UNITED STATES PATENT AND TRADEMARK OFFICE

10/694,723

Office Action Summary

DETAILED ACTION

FIG. 12a

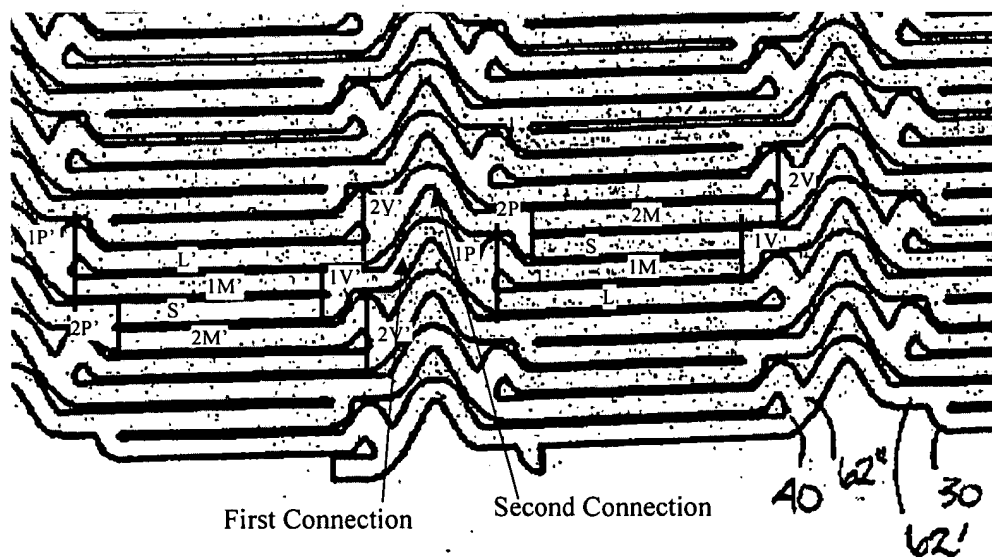
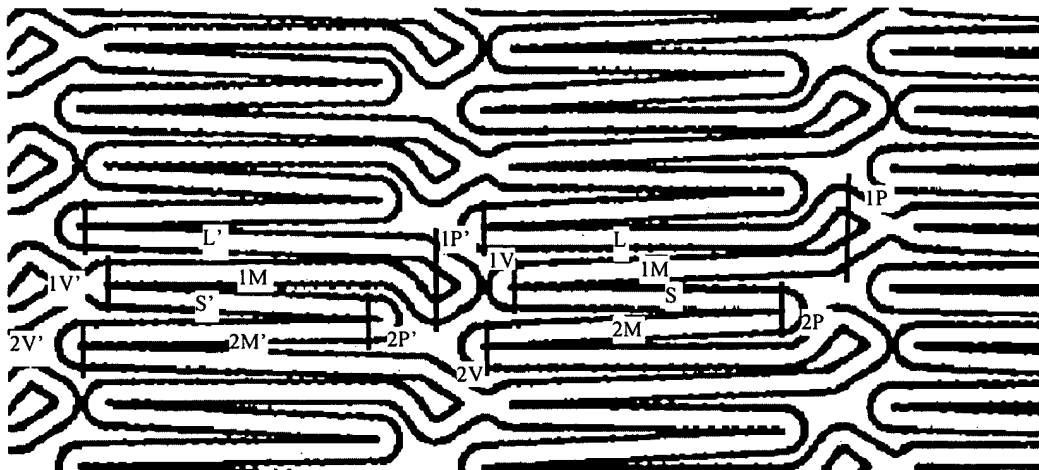
5. Claims 1-7, 9-13, 16-22 rejected under 35 U.S.C. 102(e) as being anticipated by Lowe et al. (US 2004/0093073).

6. Lowe discloses a stent in Figures 23 and 24. The figure is copied and labeled below to depict the long segment (L), first peak (1P) being defined by a single turn radius, connecting with a midsize segment (M), connecting with a first valley turn (1V), connecting with a short segment (S), connecting with a second peak turn (2P), connecting with a second midsize segment (M), and connecting with a second valley turn (2V), connecting with a long segment of the adjacent series. It should be clear that the first peak turn of one element is connected to the first valley turn of an adjacent element. Each element has a first connection point connecting a first peak of the first element to a first valley of an adjacent second element and a second connection point connecting a second peak of the first element to a second valley of the second element. The connection points form a double helix pattern. The elements are formed connected, welded or from toroidal rings (Para [0095]). The stent is balloon expandable (Para [31]). Regarding claim 19, the connecting member (64, Fig. 12) spans between one of the

long segment of the first element and one of the long segments of the second element in both a longitudinal and radial direction. Note that the claim does not require that the connecting member extend directly from the long segment but rather in the broadest interpretation, merely requires that the spans in a radial direction somewhere between the two segments.
